09/845,782

Bret L. Howell

Office Action Summary

FIG. 9

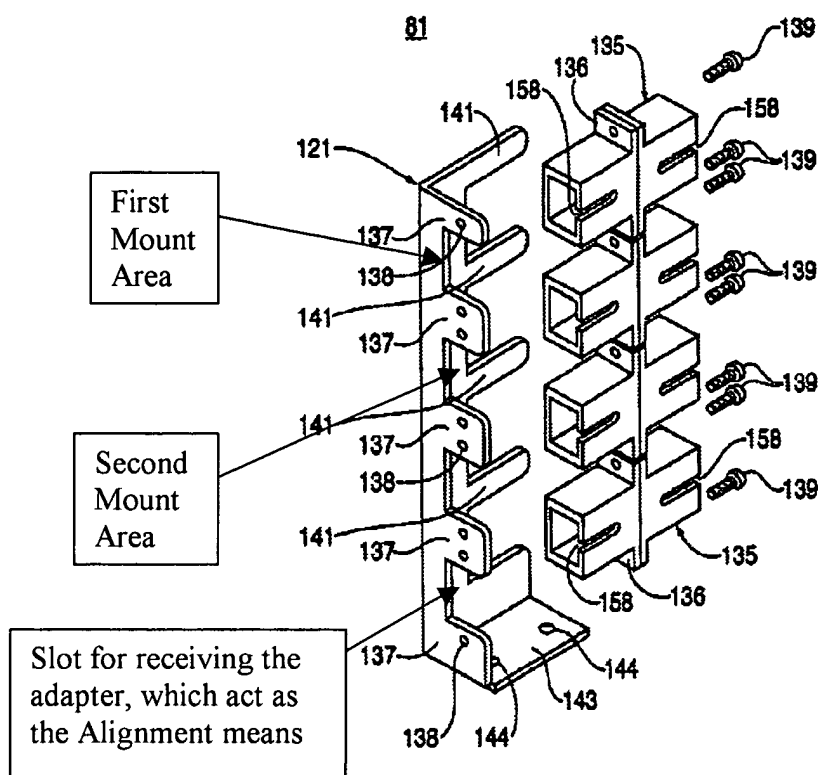
15. Claim 27 is rejected under 35 U.S.C. 103(a) as being unpatentable over Kusuda et al (6,644,866 B1).

Kusuda discloses a fiber optic cable adapter holding structure 81 comprising a first adapter mount area and a second adapter mount area, each mount area configured to receive SC-type adapter 135. Each mount area includes an alignment means (a slot for receiving the adapters on the attachment surface 137) to position the adapter and an attachment means 138 and 139 to secure the adapter to the mount area. Although Kusuda does not disclose FC-type adapter to be attached on the adapter mount area, Kusuda teaches in the prior art Figure 31b that FC-type adapter can be used.

It would have been obvious at the time the invention was made to a person having ordinary skill in the art to modify the adapter holding structure taught by Kusuda such that it would attach FC-type adapter as taught by the prior art of Kusuda because it only deals with using one type of known adapter over the already known other type adapter.
